ADDENDUM NO. 1

ROCK RIVER WATER RECLAMATION DISTRICT FULLER CREEK PHASE F, SOPER STREET FORCEMAIN CAPITAL PROJECT NO. 1153, IEPA PROJECT NO. L17-5306

VILLAGE OF WINNEBAGO WATER MAIN IMPROVEMENTS AND WESTFIELD CULVERT REPLACEMENT

This Addendum Number 1, dated April 12, 2018 for the above referenced project, supersedes all contrary and conflicting information in the specifications and contract documents, which are hereby supplemented or revised as follows:

31 of 37

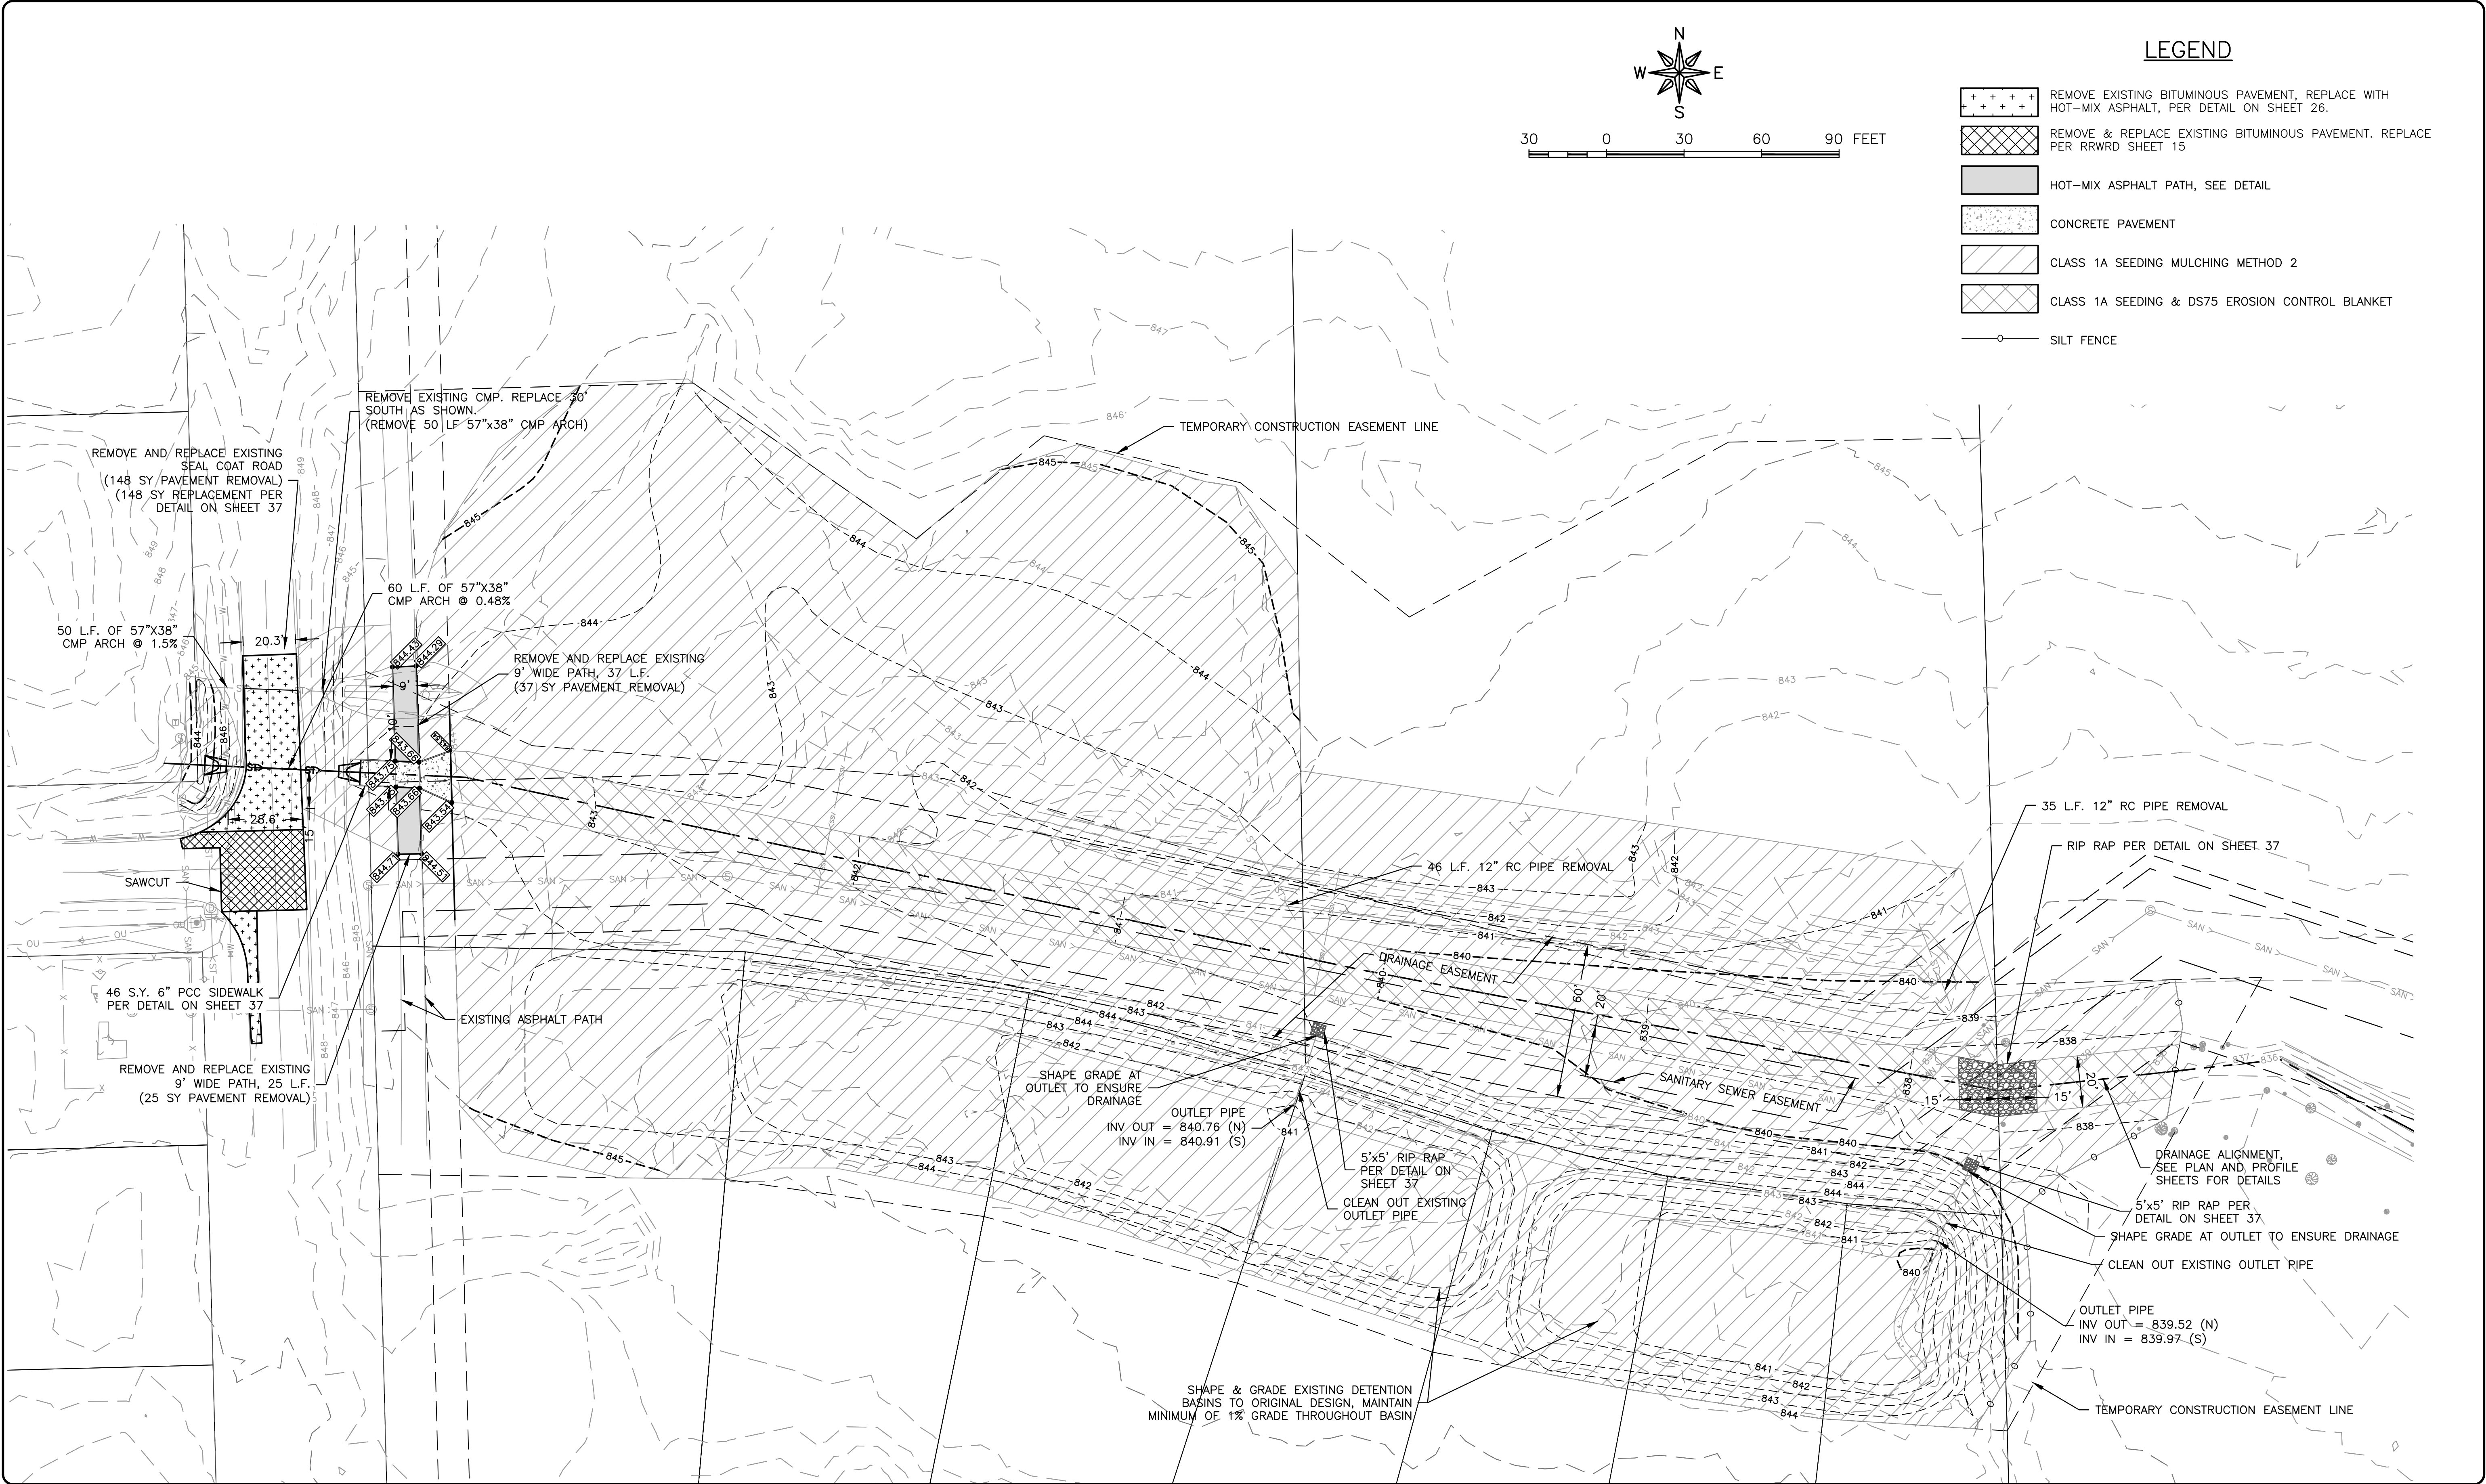
1. Replace the following plan sheets with the attached revised plan sheets
 - a. Sheet 3 – The Summary of Quantities has been updated to reflect changes.
 - b. Sheet 31 – Quantities have been updated.
 - c. Sheet 34 – Proposed grading plan has been revised and temporary easement limits adjusted.
 - d. Sheet 35 – Proposed grading plan has been revised.
 - e. Sheet 37 – Rip Rap has been revised to RR2 gradation.
